BURLINGTON DEVELOPMENT REVIEW BOARD

Tuesday October 1st, 2019, 5:00 PM

TO: Development Review Board
FROM: Scott Gustin
DATE: October 1, 2019
RE: 19-0930CA; 221-223 Saint Paul Street

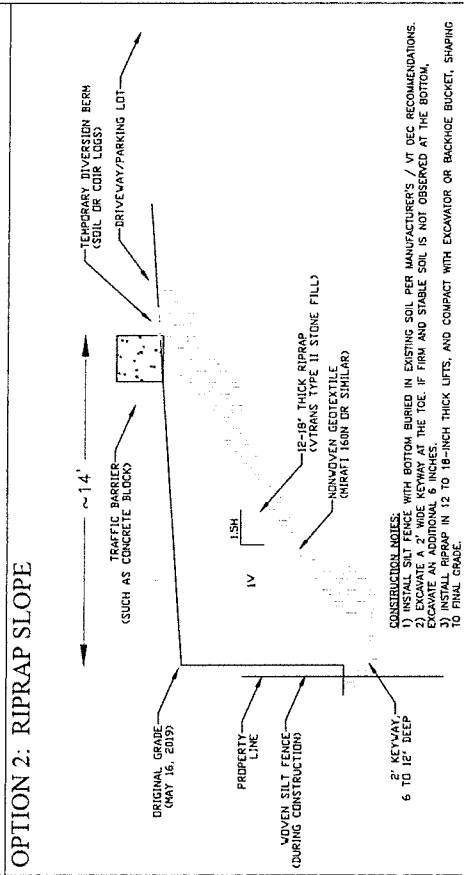
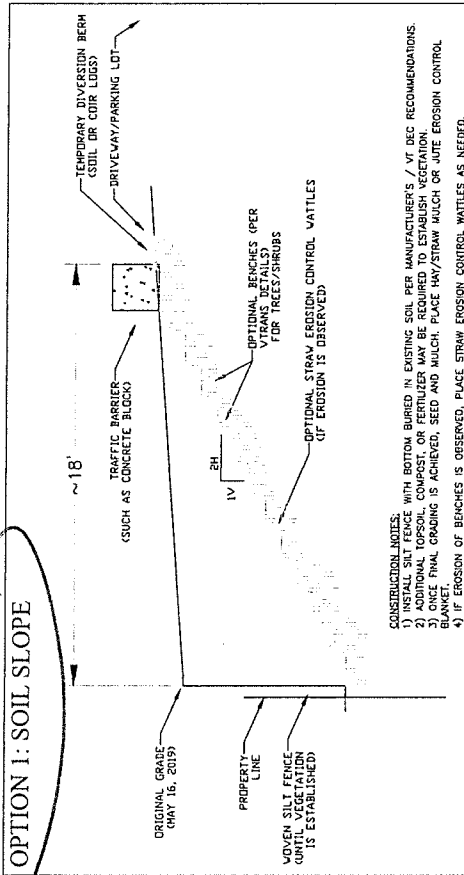
The proposed grading plans for Option 1 clearly depict soil being pulled back to a more gradual slope of 1’ vertical rise for every 2’ horizontal distance. No soil is permitted to be placed up against the neighboring building. The toe of the proposed slope is even with the grade of the adjacent property.

1. Prior to release of the zoning permit, a revised site plan clearly depicting the limits of the proposed grading work and impacts, if any, to onsite parking shall be submitted subject to staff review and approval.
2. Prior to release of the zoning permit, the applicant shall fully resolve the outstanding Dangerous Building Order and Stop Work Order issued by the Department of Public Works and currently affecting the property.
